# Introduction

The applicants, most parties to this docket, and over 270 individuals provided written comments on the ERGS draft EIS. Many members of the public also provided oral comments regarding the draft EIS to PSC and DNR staff during the public meetings conducted in the city of Oak Creek and the town of Caledonia during late May 2003. Comments from the applicants, parties, and the public generally provided substantive information, constructive criticism, or questions regarding the content of the draft EIS. Some comments were related to PSC and DNR review procedures or expressed personal opinions about the proposed project. All written comments postmarked by June 15, 2003 and the information obtained during public information meetings were considered in the development of this final EIS.

## Chapter 2 PTF Costs and Financing Mechanism

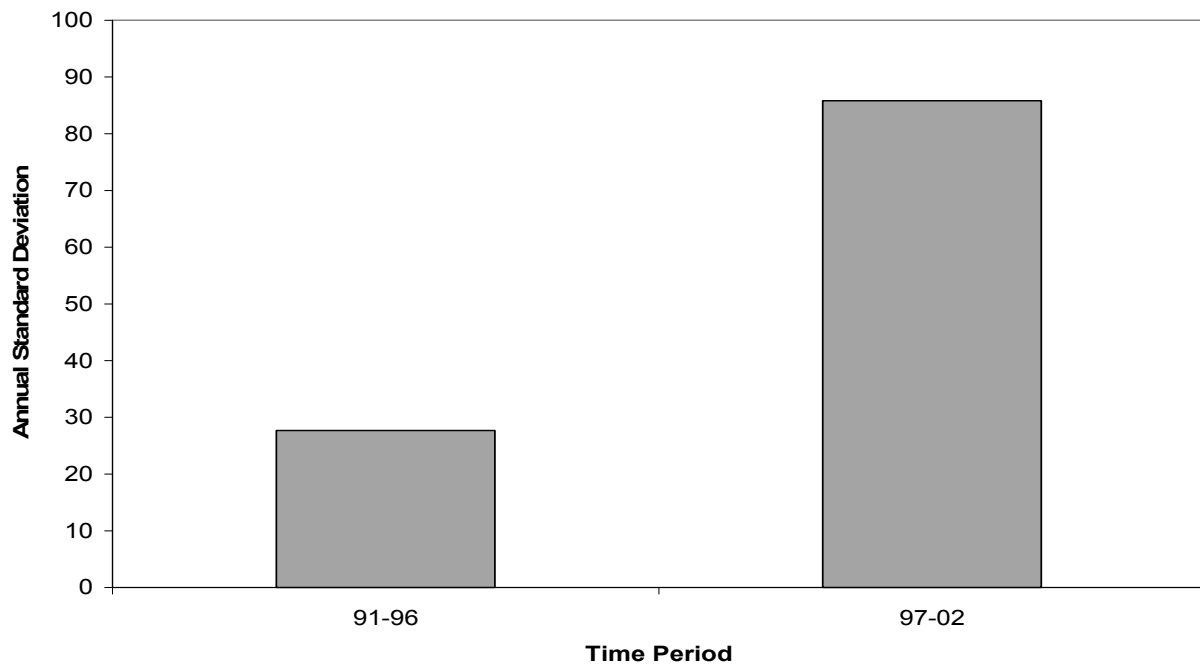
-----  
***ANR Pipeline Company states in reference to problems experienced on the ANR Pipeline system last winter as follows: “[A] reference to a single unique situation hardly acts to validate that there is a legitimate concern about the reliability of natural gas pipelines to provide service at contracted levels.” – (ANR Pipeline)***

It is true that natural gas prices can be forecasted based on long-term trends in the historical data. What is critically important, however, is that the forecasts from such a model be accurate and that they appropriately reflect the inherent volatility of the data in question. When data are statistically non-stationary, as is the case with natural gas prices, long-term trend models, such as the one recommended by S.C. Johnson, tend to produce very poor forecasts relative to other models.<sup>2</sup> While it may appear to be a simple model, the random-walk model used in the draft EIS is much more sophisticated in a statistical sense than is a trend model, and research has shown that the random-walk model will tend to produce more reasonable and more accurate forecasts.<sup>3</sup>

For a trend model to be valid in this circumstance one of the conditions that must be satisfied is that natural gas prices must have, among other things, a constant long-term variance.<sup>5</sup> If this condition is not satisfied, then the trend model does not provide useful forecasts of the degree to which natural gas prices can vary. We can see that the variance of natural gas prices is far from constant. In recent years prices have been much more volatile than those of the prior periods, as is shown in the following chart.

No modification to the analysis of future natural gas prices is required for the final EIS.
